**TYPICAL EQUIPMENT
 LINE EQUIPT RACK A
 UNIT AUTO N.Z.13.**

494063 SH-1-5 AUTOMATIC TELEPHONE & ELECTRIC CO LTD LIVERPOOL

**TYPICAL EQUIPMENT
 LINE EQUIP! RACK "A"
 UNIT AUTO N.Z.13.**

494063 SH.5-5 AUTOMATIC TELEPHONE ELECTRIC CO LTD LIVERPOOL

FIG. 1

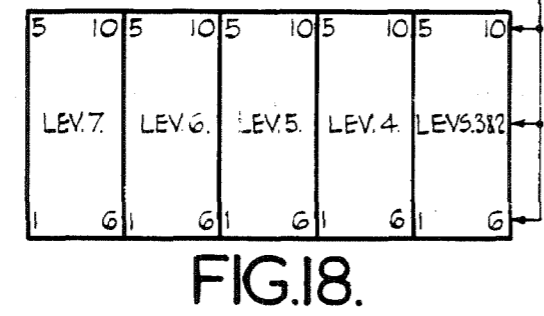
ISSUE	APP
1. 13. 1. 54	H.A.B.
2. CO. 1932 FIG. 1 SHELF A. REL. CA WAS NOT SHOWN. 26.9.55	H.P.B.
3. CO. 2910 IN FIG. 1. FUSE PANEL POSN'S REVISED. FIG. 1 SHELF A REL. 'GFA' WAS OFF. 2.12.55	H.P.B.
4. CO. 4572 NOTE 1-1 WAS NOT SHOWN. 8.2.56	H.P.B.
5. CO. 4970 DESIGN OF RELAY OFFR WAS OFF. 27.2.56	H.P.B.

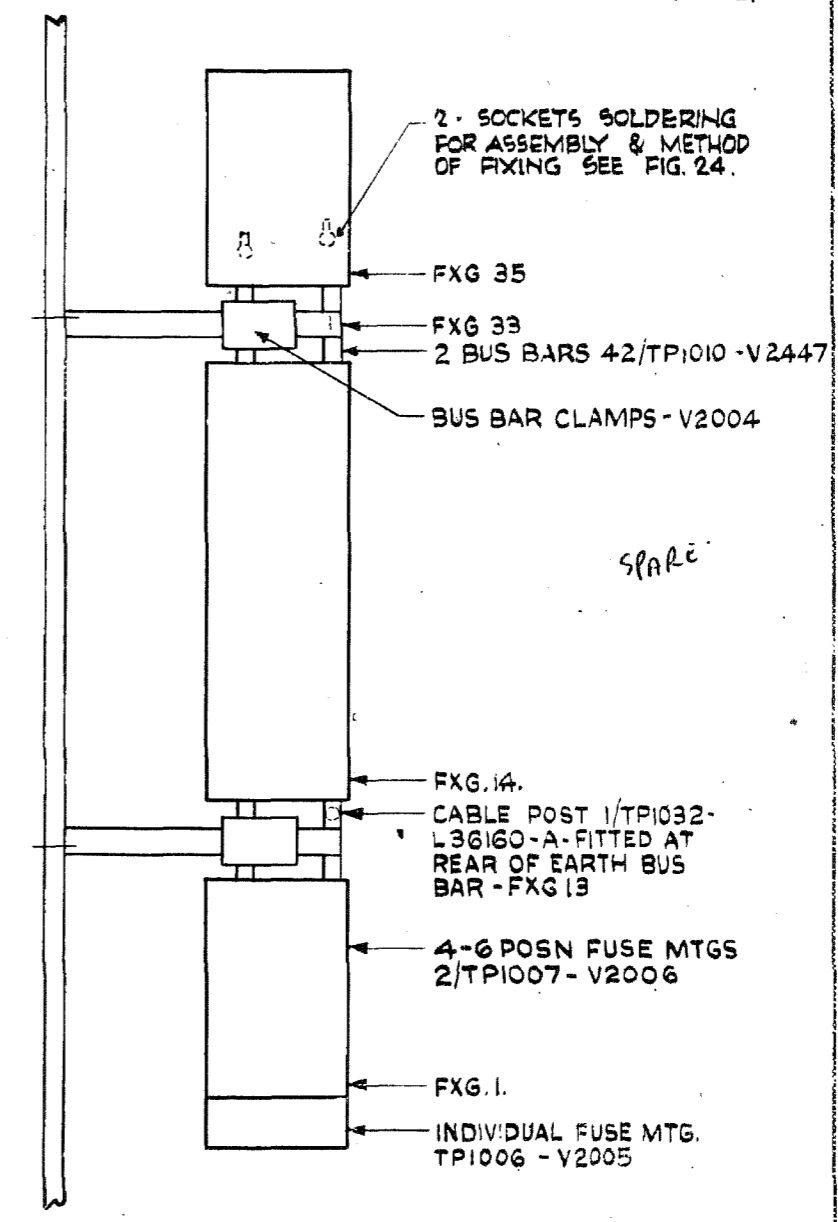
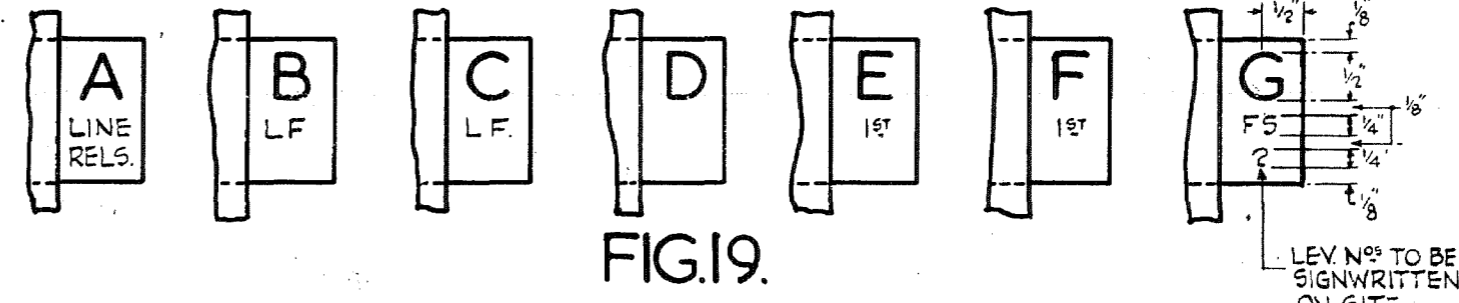
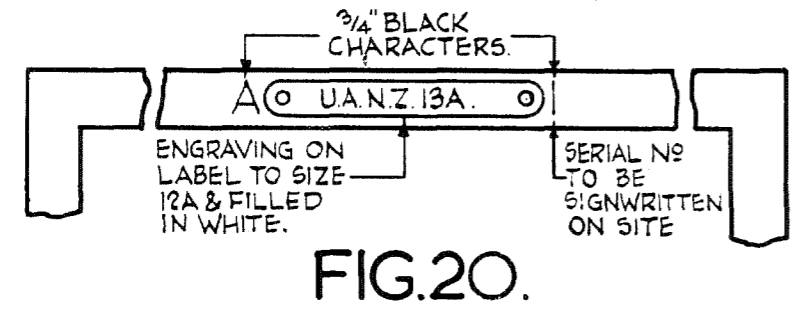
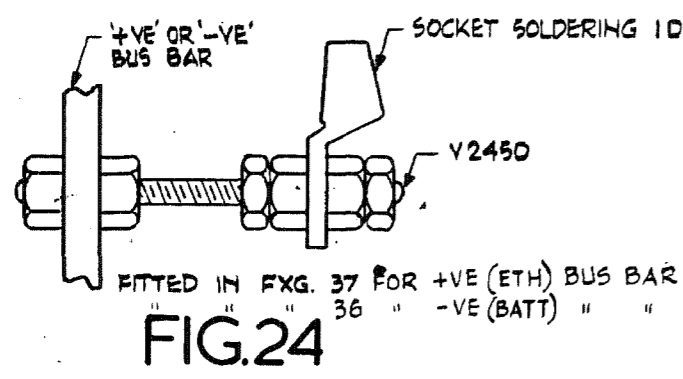
ISSUE	APP
1. 13. 1. 54	JGB
2. C.O. 2910 FIGS 23 & 24 WERE NOT SHOWN.	JGB
2 - 12 - 55	MRB
3. C.O. 7796 SOCKET SOLDERING ID WAS 3D IN FIG.24	ACB
27-10-61	MRB
